Wyong Shire Council

ORDINARY MEETING

3.1 DA/526/2011 - Construction of Three Proposed Industrial Units at Berkeley Vale

Construction of Three Proposed Industrial Units at Berkeley Vale

FIGURE 2: Original site plan (since amended to provide continuous perimeter access road as shown in Attachment 1.)

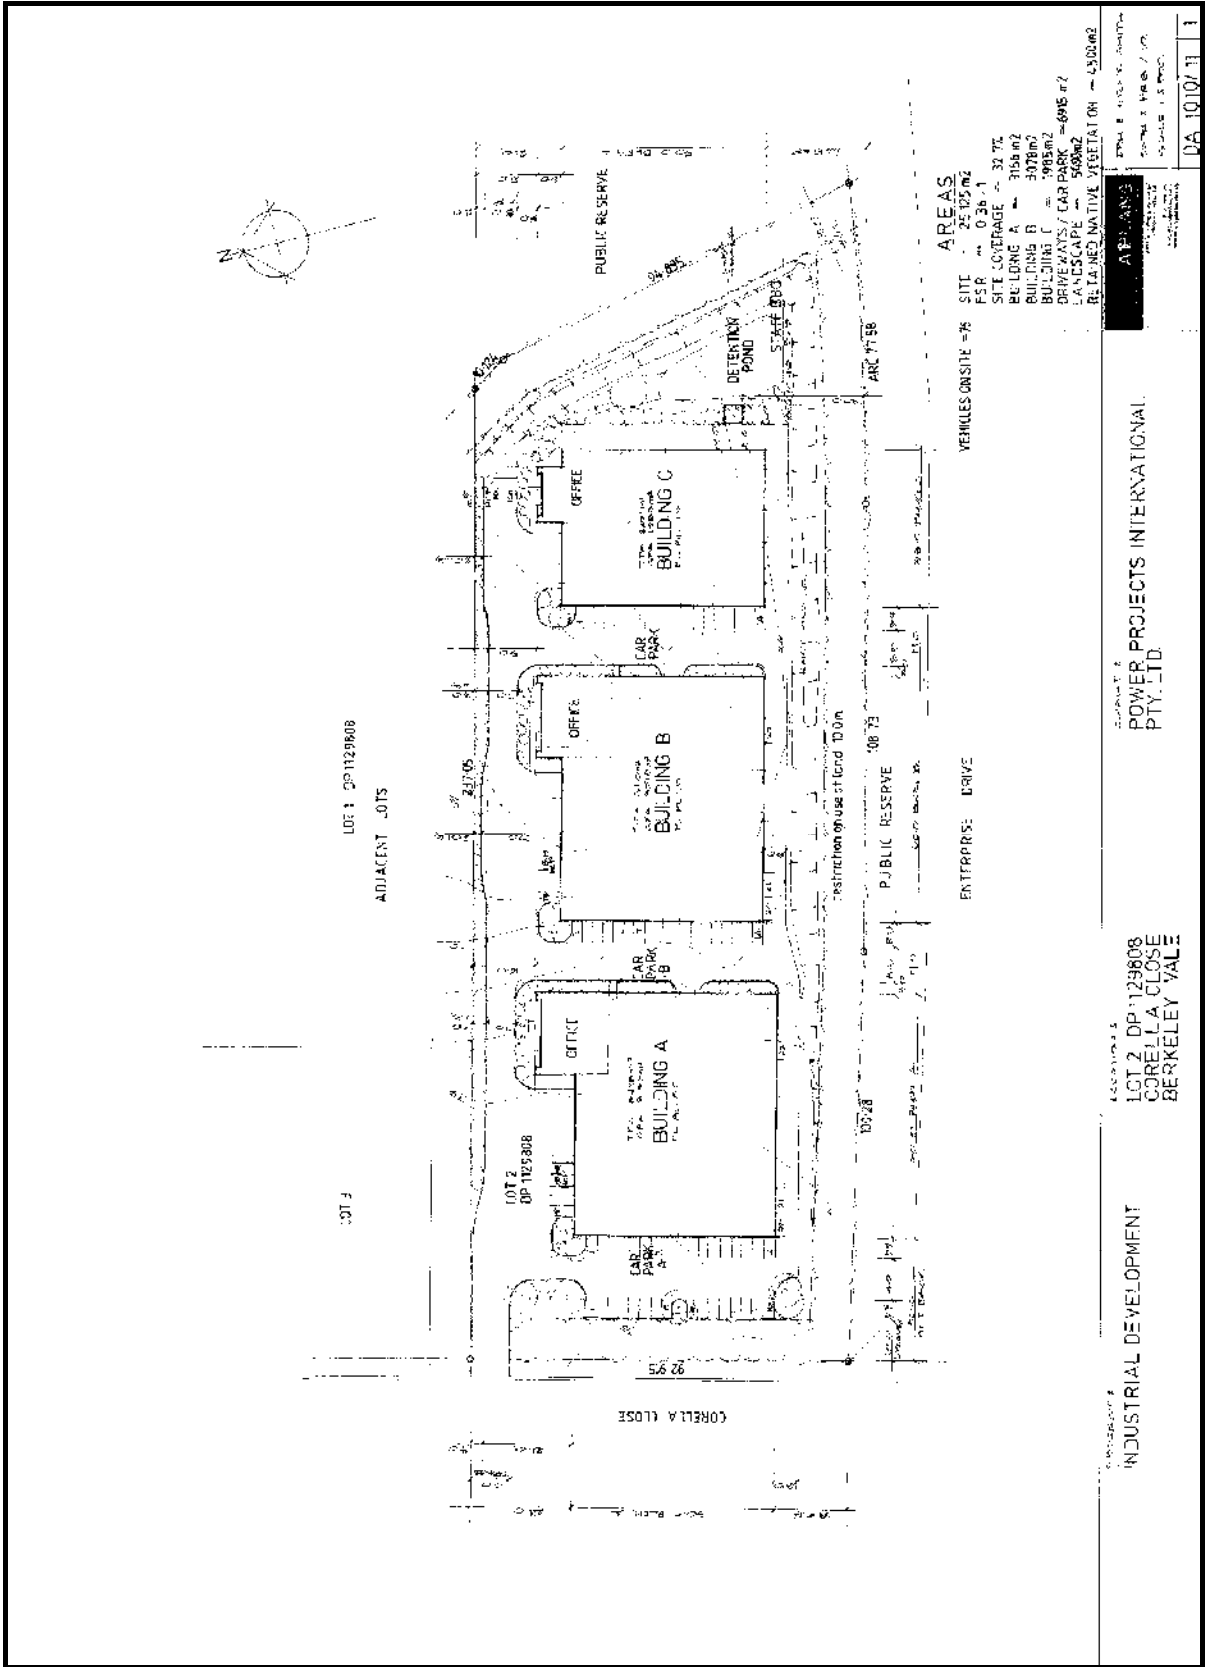
It should be noted, however, that Council required the site plan (shown in Figure 1) to be amended in the location of the north-eastern corner of Building “C” to provide a continuous access perimeter road for bushfire-fighting vehicles. This amendment is shown in the current site plan in Attachment 1.

It should be further be noted, however, that notwithstanding the bushfire hazard assessment, Council required the site plan (shown in Figure 1) to be amended in the location of the north-eastern corner of Building “C” to provide a continuous access perimeter road for bushfire-fighting vehicles. The applicant agreed to this amendment and the amendment is shown in the current site plan in Attachment 1.
